Comment #45 :  
PRBS31 verifier  
count rate

# Comment #45

Figure 49–11—PRBS31 pattern checker

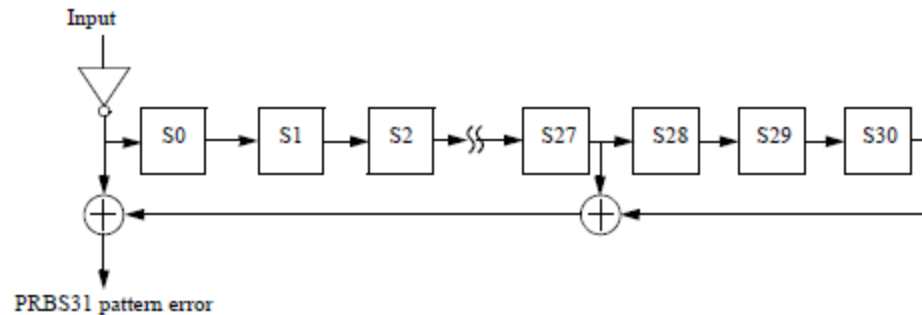
- There is no flexibility in the 49.2.12 pattern checker implementation clause
  - Compliance requires an exact match to this implementation, even at BERs worse than 1e-3
- For single bit errors, each causes 3 pattern error counts
  - This is not the way PRBS31 verifiers are normally implemented in SERDES or BERTs
  - The count from bursts depends on the position of errored bits in the burst (error cancellation can occur)

*The checker shall increment the test pattern error counter by one for each incoming bit error in the PRBS31 pattern (see 49.2.8), for isolated single bit errors at least a thousand bits apart. Otherwise the checker should attempt to count all incoming bit errors.*

# Implementation Considerations

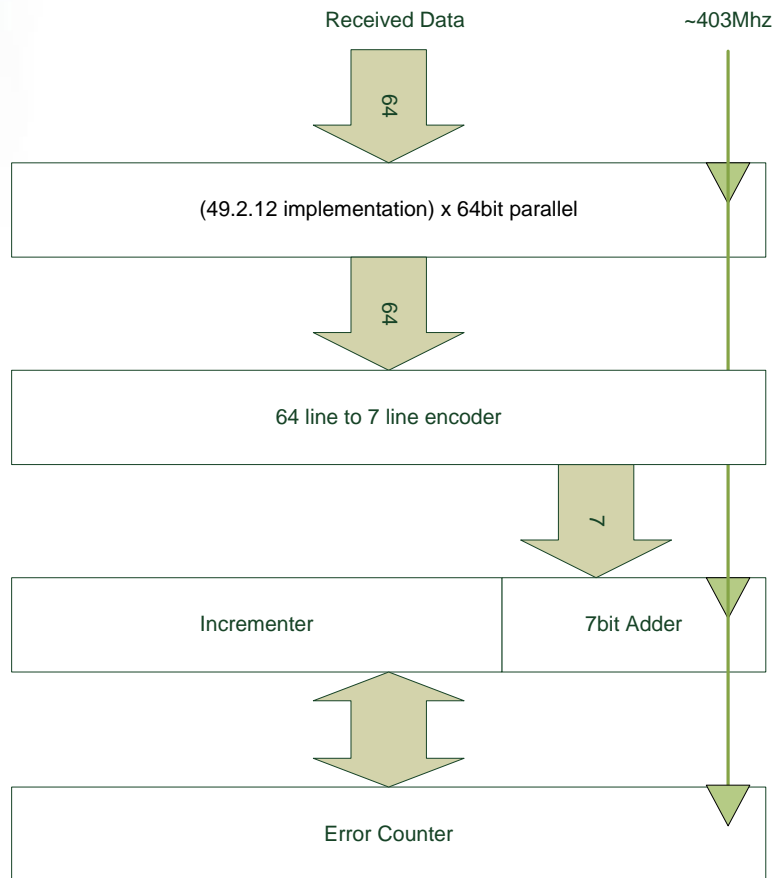
- It is not practical to implement Figure 49-11 at 25.8Ghz. It has to be parallelized.
  - A 64bit parallel version would run at ~403Mhz
    - ❖ For low BERs between 0 and 3 bit errors may require detecting and counting per cycle
    - ❖ For high BERs or bursts, 0 to 64 bit errors may require detecting and counting per cycle
  - Up to 64 errors must be detected and counted per cycle, worst case
    - ❖ This is not impossible to do, just highly complex !
      - This logic complexity may be acceptable in a multi-million gate PCS/MAC chip, but is a huge overhead for a PMA device.
    - ❖ What system advantage is gained by requiring this complexity ?

# What do we really need in a PMA ?

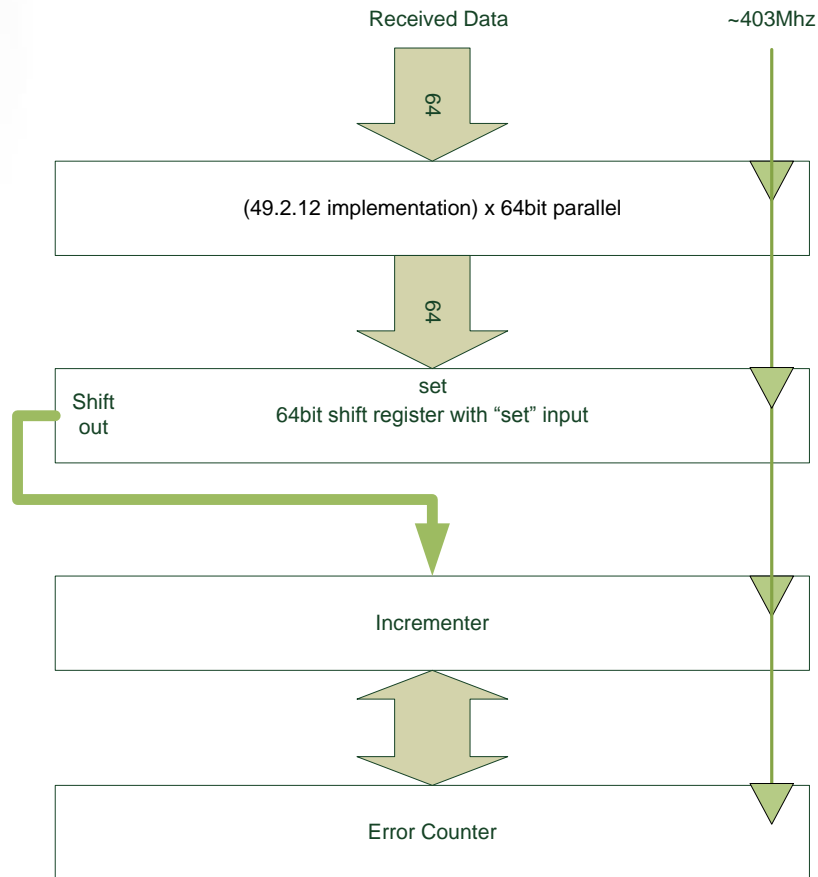
- Do we really want an error count that is 3x the BER ?
- Is accurate error counting at BERs worse than  $1e-3$  required ?
  - I believe not
- Is accurate counting of burst error bits required ?
  - Figure 49-11 does not do this anyway !
- For most practical purposes stringent matching of Figure 49-11 is not necessary.
  - It would be sufficient to match the result of Figure 49-11 only for isolated single bit errors and at errors rates less than 1 in a thousand.
